316
319
Alouette

No. 05.80

SUBJECT : TIME LIMITS

Monitoring the Yaw Control Pedal Unit Support
P/N : 3160S-86-12-300 or 3160S-73-86-380.

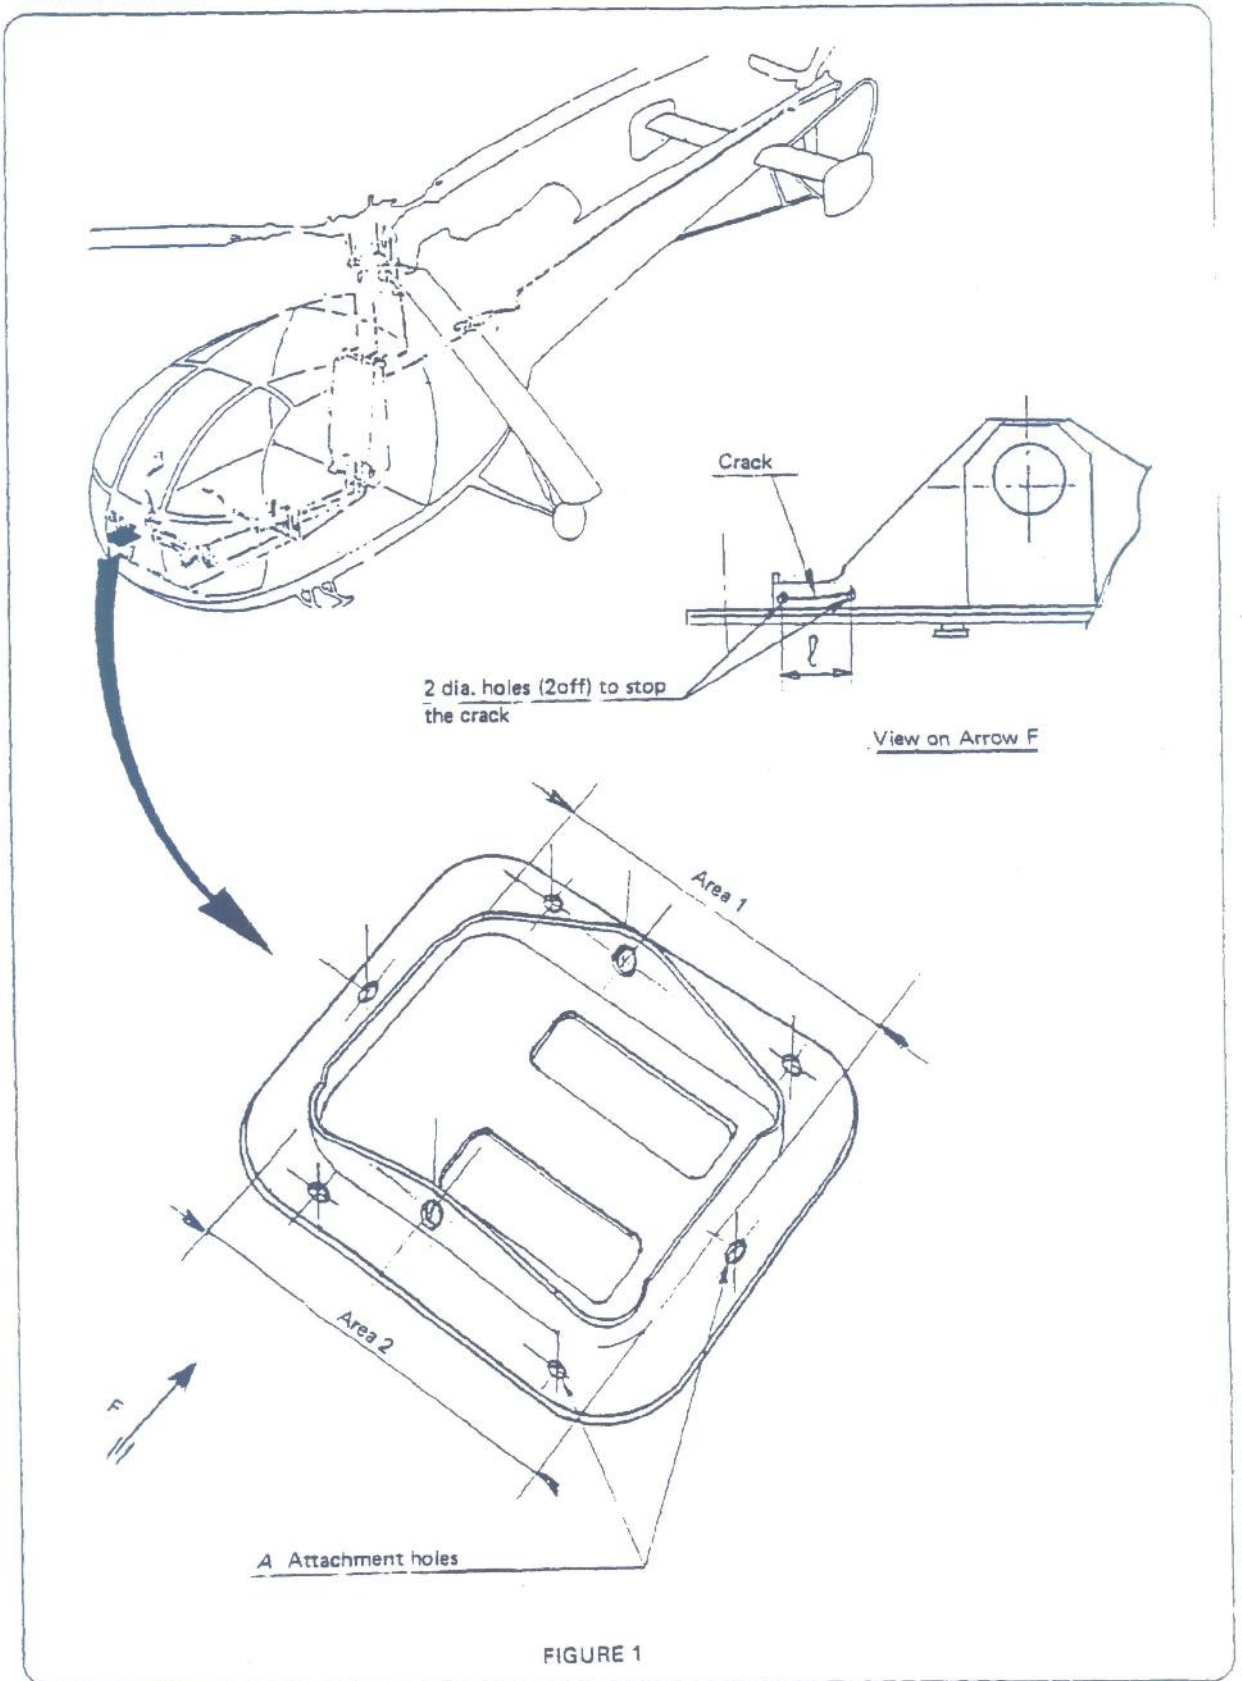
- (b) Perform a dye penetrant crack detection inspection (as per Standard Practices Manual Work Card 20.02.01.01) in areas 1 and 2 on the bend radii and flanged edges.

- (a) If no cracks are found, reinstall the support
(b) If a crack is found, measure its length "l" :

(ba) - If "l" is equal to or less than 60 mm :

. Drill a 2 mm dia. hole at each end of the crack and reinstall the assembly,
then :

. Every 100 flying hours, remove the support to check for any development of the crack.

(bb) - If "l" is greater than 60 mm, replace the support within 50 flying hours
